# UNITED STATES PATENT AND TRADEMARK OFFICE

APPLICATION NO.	FILING DATE	FIRST NAMED INVENTOR	ATTORNEY DOCKET NO.	CONFIRMATION NO.
10/751,247	12/31/2003	Masahiro Yamanaka	SIC-02-009-3	3824
29863	7590	02/06/2006	EXAMINER	
DELAND LAW OFFICE P.O. BOX 69 KLAMATH RIVER, CA 96050-0069			LUONG, VINH	
			ART UNIT	PAPER NUMBER
			3682	
DATE MAILED: 02/06/2006

# Office Action Summary

# **ATTACHMENT 1**

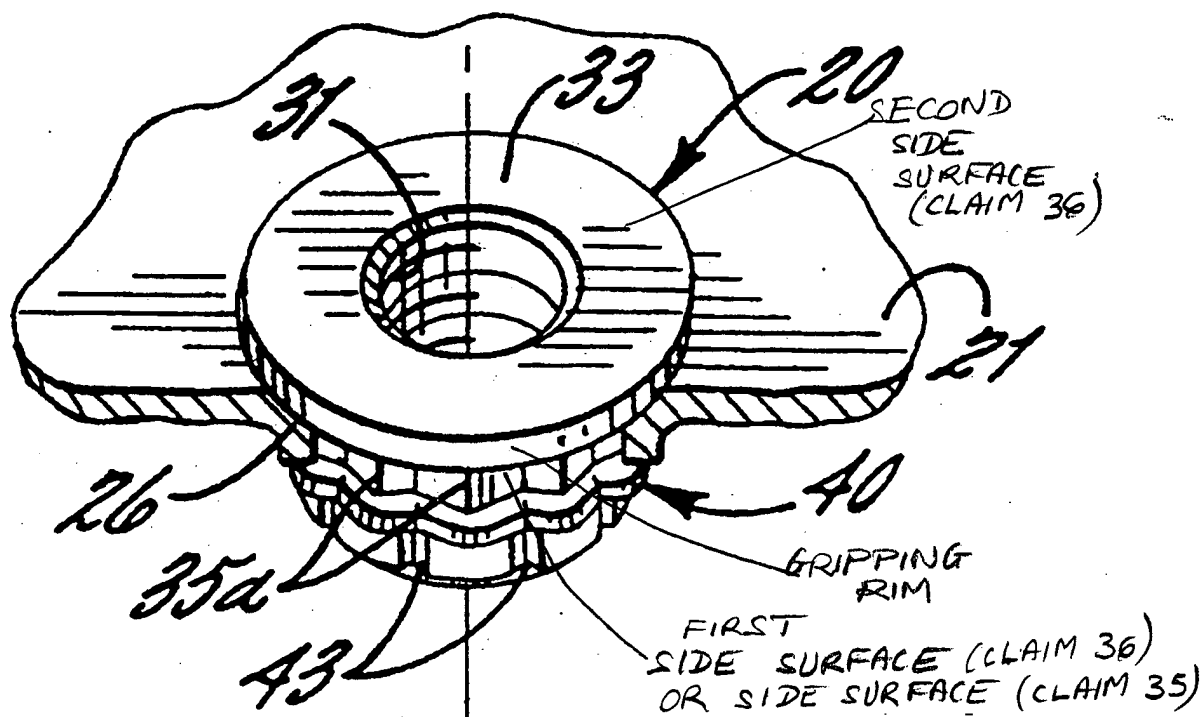
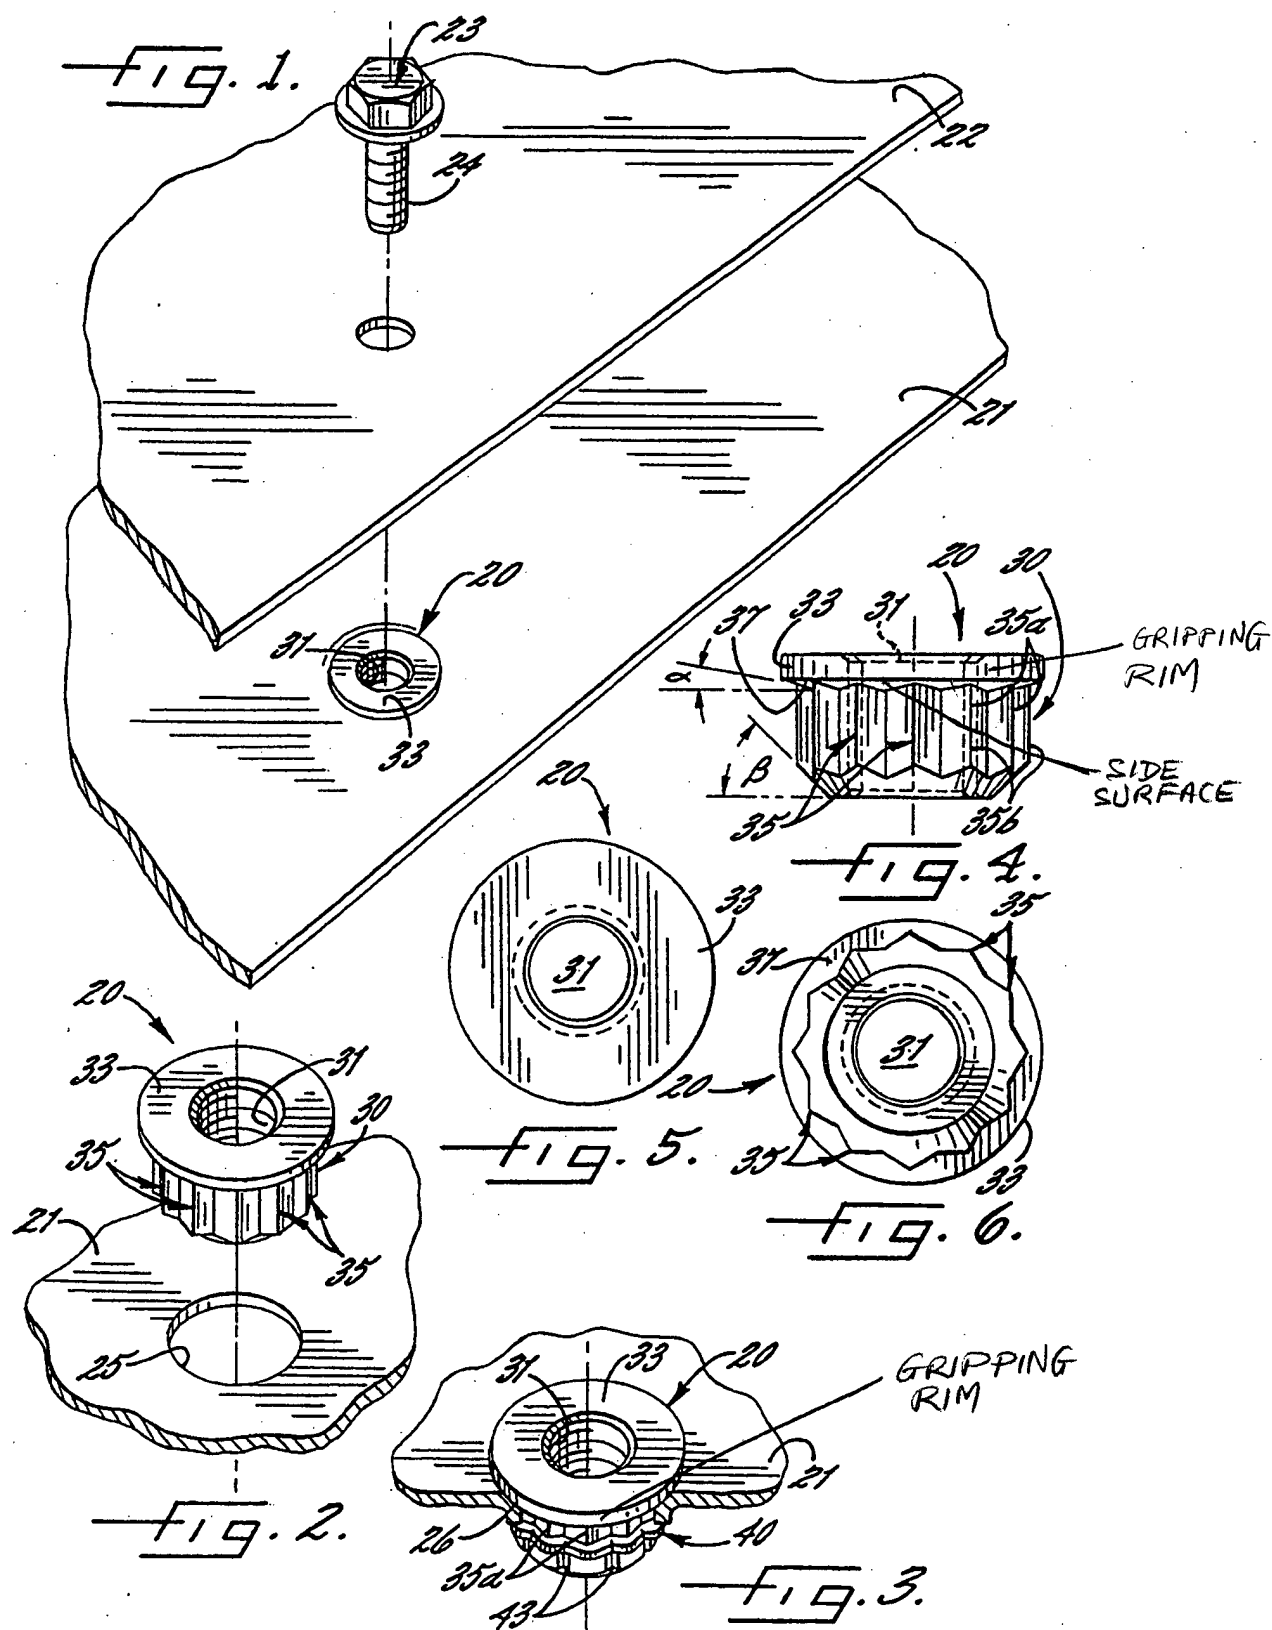
Regarding claim 24, the tool body 30 extends from a side surface (see Attachment 1) of the tool operating member 33.

Regarding claim 26, the tool operating member 33 includes a gripping rim (at 33 in Fig. 4. See Att. 1) extending from a side surface thereof.

Regarding claim 28, the tool body 30 extends from a first side surface (Att. 1) of the tool operating member 33, and wherein the gripping rim 33 extends from an opposite second side surface (Att. 1) of the tool operating member 33.

Regarding claim 35, Fultz teaches a tool 20 for a bicycle crank axle bolt comprising: a tool body 30; a plurality of splines 35 circumferentially disposed on and extending radially outwardly from the tool body 30; a tool operating member 33 projecting radially outwardly from the tool body 30; and a gripping rim (at 33 in Fig. 4. See Att. 1) that projects axially away from a side surface (Att. 1) of the tool operating member 33, wherein the gripping rim (Att. 1) forms an axially outermost surface of the entire tool.

Regarding claim 36, Fultz teaches a tool 20 for an axle bolt comprising a tool body 30; a plurality of splines 35 circumferentially disposed on and extending radially outwardly from the tool body 30; a tool operating member 33 including a gripping rim (Att. 1) projecting radially outwardly from the tool body 30; wherein the tool body 30 extends from a first side surface (Att.

1) of the tool operating member 33; and wherein a gripping rim (Att. 1) projects axially away from an opposite second side surface (Att. 1) of the tool operating member 33.

Third, Applicant contended that Fultz's flange 33 is not the gripping rim. Nevertheless, contrary to Applicant's subjective observation, Fultz discloses or suggests a gripping rim that projects axially away from a side of a tool operating member as recited in claims 35 and 36. Indeed, Fultz's gripping rim is substantially identical to Applicant's gripping rim 474 in Applicant's Fig. 10. One having ordinary skill in the art plainly can grip the outer surface of Fultz's flange 33 by his/her hand, thus, that outer surface "reads on" Applicant's gripping rim. Applicant apparently uses an "*ipsissimis verbis*" test that requires the same terminology in the art in order to find anticipation. See footnote 11 of *AKZO N.V. v. International Trade Commission*, 1 USPQ2d 1241, 1245 (CAFC 1986). It is well settled that an inventor can be his/her own lexicographer. Thus, Fultz does not need to use the same terminology as Applicant uses. Simply put, since one can grip the outer surface of the flange 33 of Fultz in the same manner as one can grip the rim 474 of Applicant, a fortiori, the outer surface of Fultz's flange 33 reads on the "gripping rim."
